# STAFF RECOMMENDATION

NCPC File No. 6321

**NATIONAL LAW ENFORCEMENT MUSEUM  
ENTRANCE PAVILIONS AND PLAZA  
JUDICIARY SQUARE, NW  
Washington, D.C.**

November 29, 2007

The following diagram, generated by staff, demonstrates the legislated building restrictions.

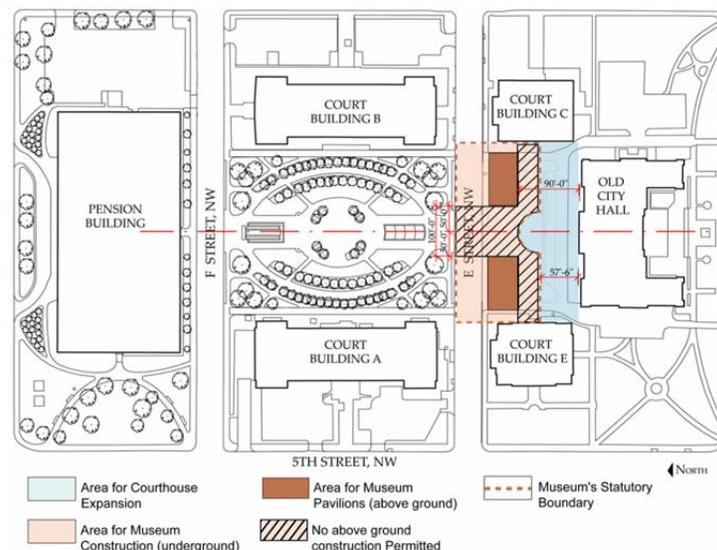
The proposed retaining walls and portions of the revolving doors used for entering each museum pavilion are placed within the 100-foot-wide axis. A third element, the landscaped beds to the south of each pavilion are proposed for an area where no above ground construction is permitted by the legislation.

The museum construction is limited to a distance of 57 feet, 6 inches from the façade of the Old City Hall plus an area extending beyond that line and comprising a part of a circle with a radius of 40 feet measured from a point that is 59 feet, 9 inches, from the center of that façade.” The legislation also requires that “above ground, there is a no-build zone of 90 feet out from the northernmost face of the north portico of the existing Old City Hall” and that “no portion of the aboveground portion of the Museum is located within the 100-foot wide area centered on the north-south axis of the Old City Hall.”
